GEN-2008-123N
Impact Restudy for
Generator Modification
(Turbine Change)

September 2014
Generator Interconnection

Figure 1: GEN-2008-123N one-line drawing

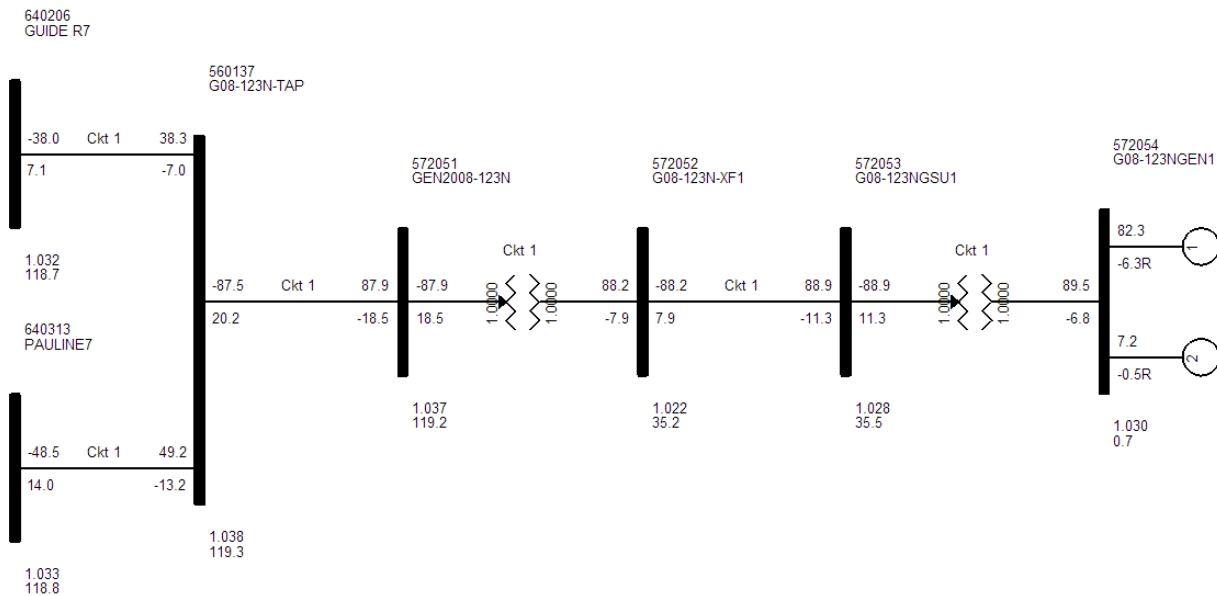
The GEN-2008-123N Interconnection Customer has requested a modification to its Generator Interconnection Agreement from fifty-two (52) GE 1.7MW wind turbine generator to a combination of forty eight (48) GE 1.715MW and four (4) GE 1.79MW wind turbine generators. Since the GE 1.715MW and the GE 1.79MW wind turbine generators have identical electrical characteristics as the GE 1.7MW wind turbine generators, a restudy was not performed for this change request. The results of the restudy performed for GEN-2008-123N (see [GEN-2008-123N Impact Restudy for Generator Modification \(Turbine Change\)](#), posted 8/19/2013) are still valid for this generation interconnection request. As the original request for interconnection is for 89.7MW, the requested change is not considered a Material Modification.

A revised one-line drawing of the project is shown in Figure 1.

With the assumptions outlined in this report and with all the required network upgrades from the GEN-2008-123N GIA in place, GEN-2008-123N with the GE 1.715MW and the GE 1.79MW wind turbine generators should be able to reliably interconnect to the SPP transmission grid.
